Project name **Station Hill Phase 1**
 Project no. **1620004716**
 Client **Lincoln MGT**
 To **Reading Borough Council**
 From **Keith Jones**

Drainage Strategy Supplementary Memo

This memo responds to the planning queries raised on the Drainage Strategy Report version C04. In particular the email from Darren Cook to Stephen Vigar dated 26th May 2020.

Comment 1

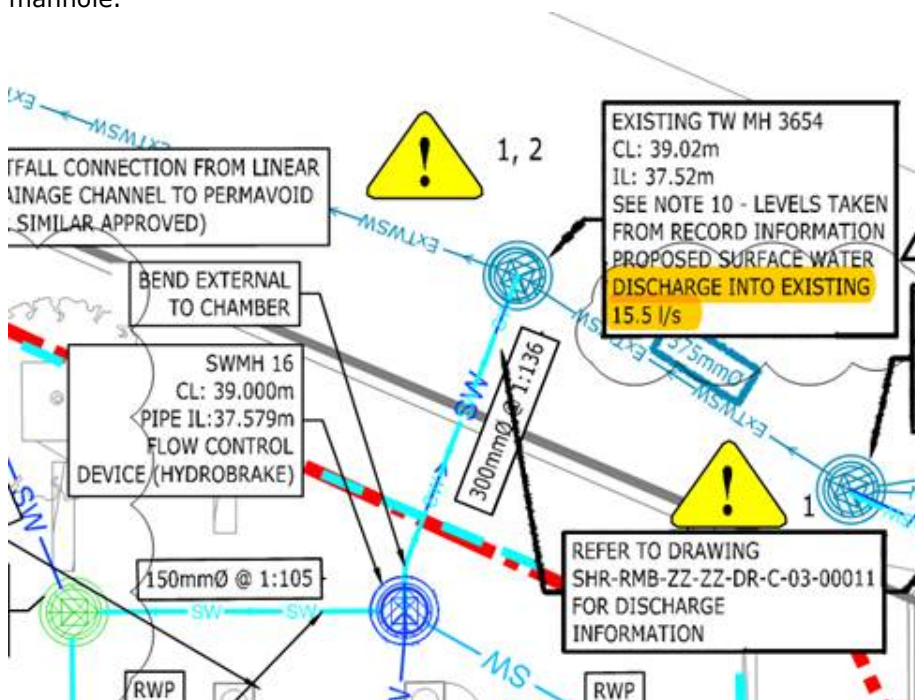
The proposed permavoid and attenuation tanks have been combined so that the discharge rates do not exceed those previously approved. However, I note that the discharge rate from the hydrobrake for Block E (North) has not been indicated on the drawing, this must be updated.

The discharge rate is noted on the existing manhole rather than the hydrobrake manhole.

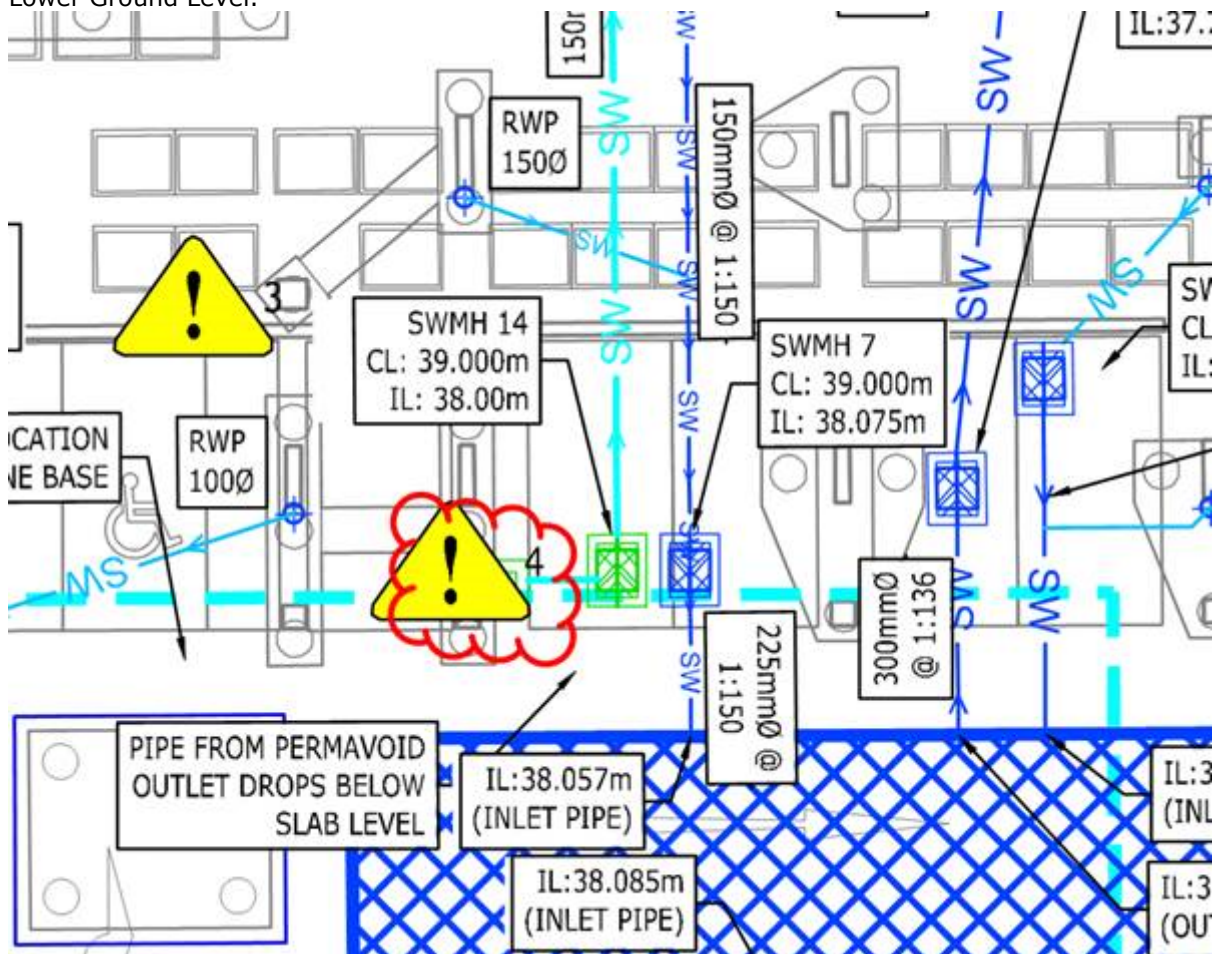
As previously stated to the north of Tank B the pipe from the permavoid drops down to the Lower Ground Floor, whereas before this dropped down in the middle of the car park aisle width this now drops down into the middle of a car parking space. This must be revised.

The drop is not in the middle of a car park space, it is adjacent to a column (as clouded in image below). The SWMH14 is in the car park space however as noted the cover level of this manhole is at Lower Ground Level.

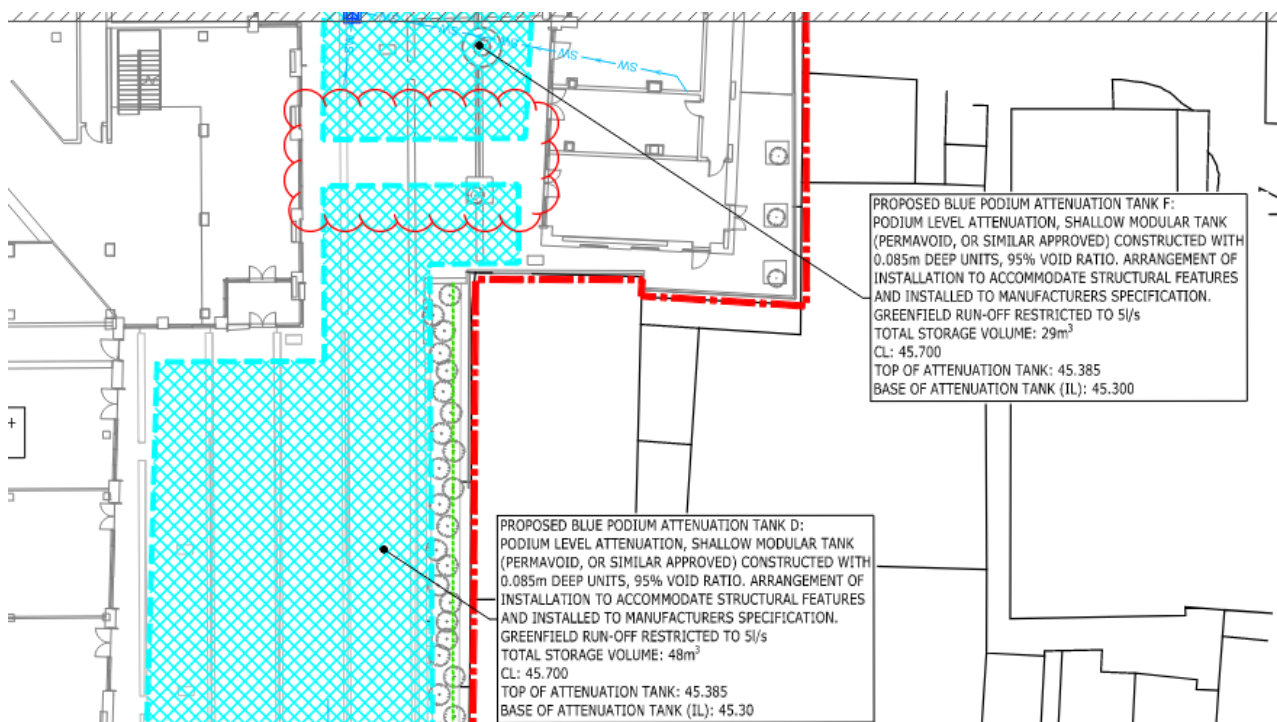
Following a review of the drawings submitted at the application stage there are trees proposed within the development that are to be planted directly into the ground that are located in areas that the permavoid is located, it would need to be confirmed what impact this would have on the storage capacity.

Final coordination between the trees planted in the ground and the permavoid will be completed at detailed design stage. The drainage strategy is demonstrating the area of permavoid that is required can be provided. The entire podium has not been filled with permavoid (see area clouded below), so there is capacity to remove permavoid in one area and move into this area to suit the final tree planting strategy.
